April 20, 1983

Subject: Steam Generator Slewing
R.E. Ginna Nuclear Power Plant
Docket No. 50-244

TUBE SHEET SLEEVE

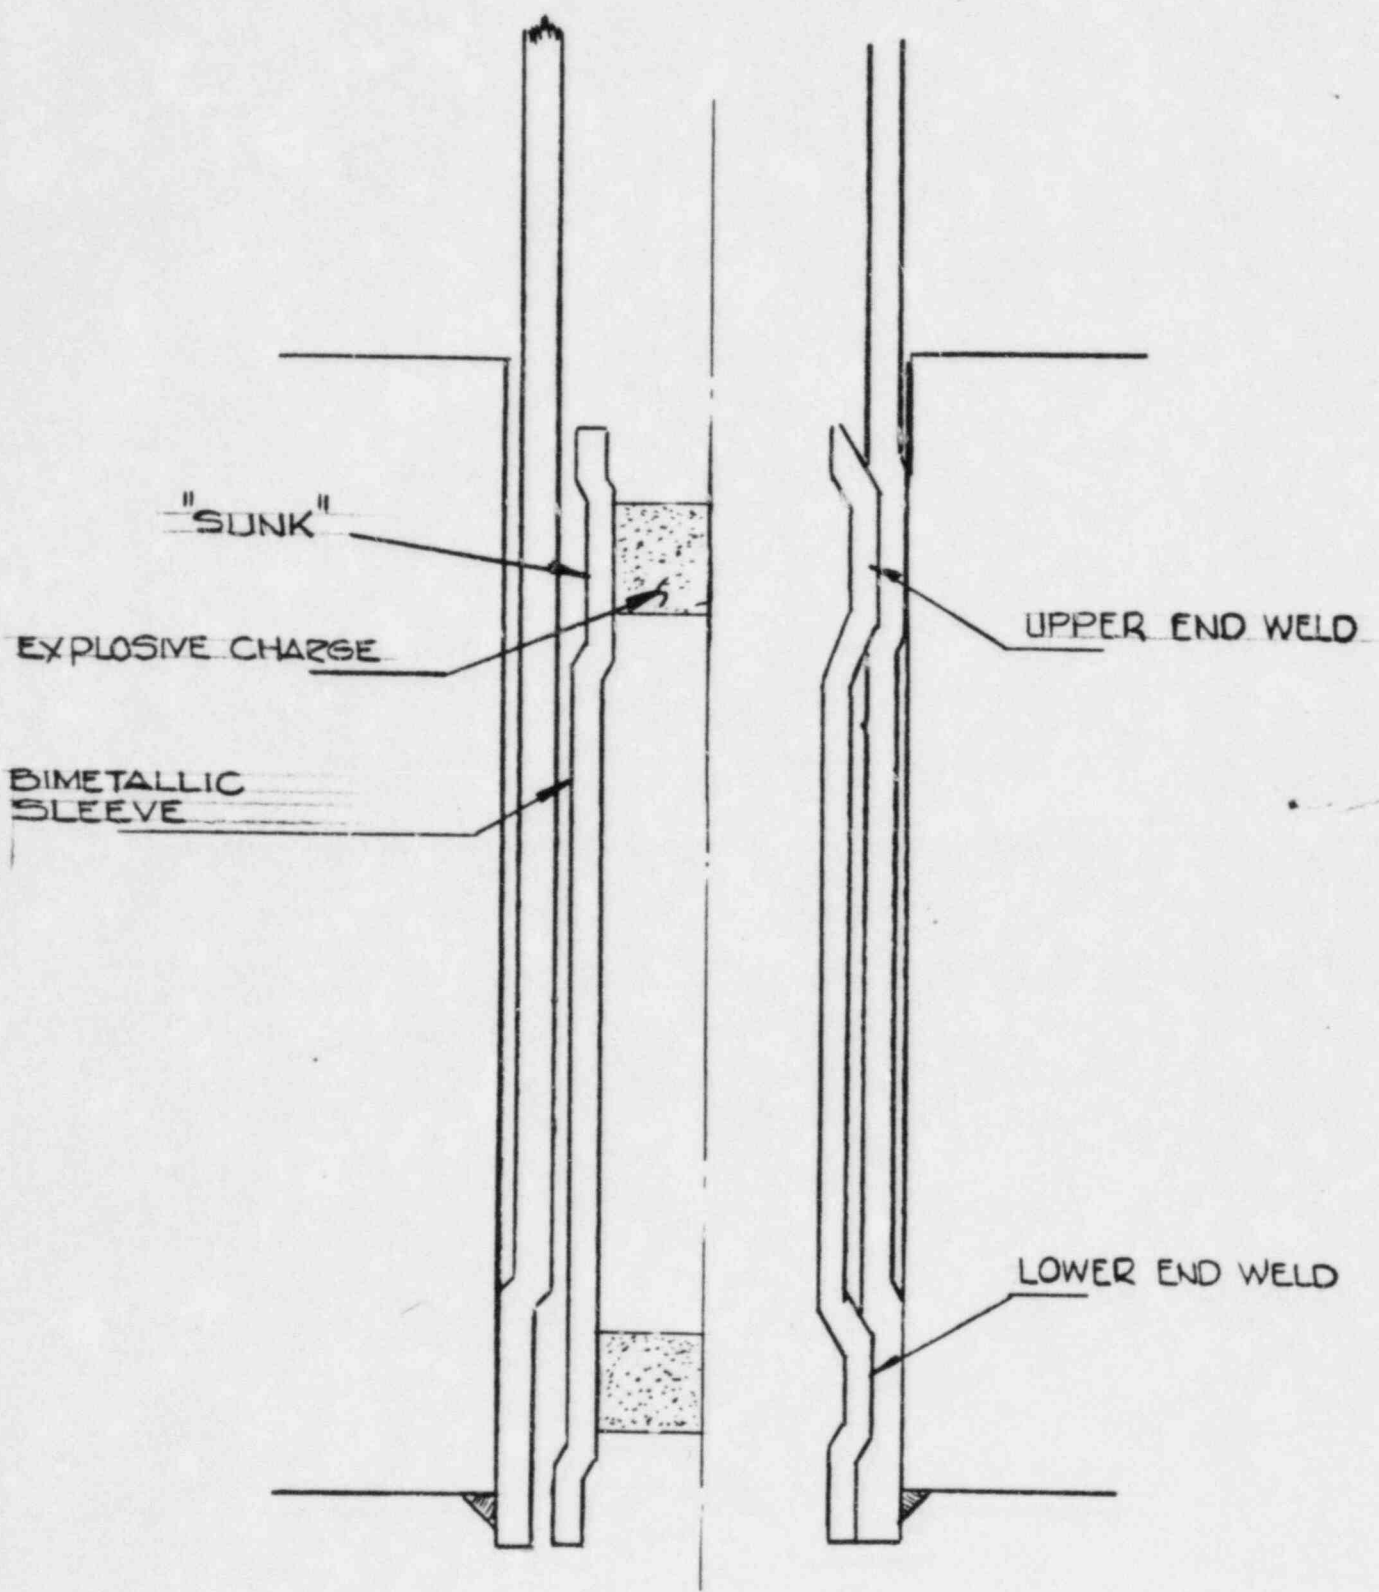
In order to provide the capability for sleeving these tubes, we have developed a modification to the present sleeve design. This modification, called a tubesheet sleeve (see attached drawing), is explosively welded at both the bottom and top. The present tubesheet sleeve design is 22 inches long. However, we anticipate development of shorter lengths in the future. The tubesheet sleeve is designed to repair tube defects which occur within the tubesheet. The tubesheet sleeve is manufactured from the same 0.745 inch nominal O.D., bimetallic tubing as the sleeves. The lower tubesheet sleeve to tube joint uses the same configuration and explosive weld process as the brazed sleeves.

The upper tubesheet sleeve to tube joint also is made using an explosive welding process. The design of this weld is based on the design of the existing lower end joint which was described in our previous submittals. This upper weld is made prior to making the lower end weld using a separate cartridge and detonation. The weld is the same length (0.75 inches) as the lower one, with its upper end a minimum of 1 inch below the top of the tubesheet. The sleeve O.D. is locally reduced over a length of 2 inches at the upper joint to provide the necessary weld standoff distance. The I.D. of the tube to be sleeved is cleaned by honing and dry swabing prior to installation of the tubesheet sleeve. The weld configuration and installation procedure were developed using a series of tests. Weld joints have been sectioned and

evaluated by metallographic examination to confirm their adequacy. The final configuration and welding procedure have been qualified to Section XI of the ASME Code in the same manner as the lower brazed sleeve joint. All qualification specimens achieved the minimum weld length of 0.75 inch.
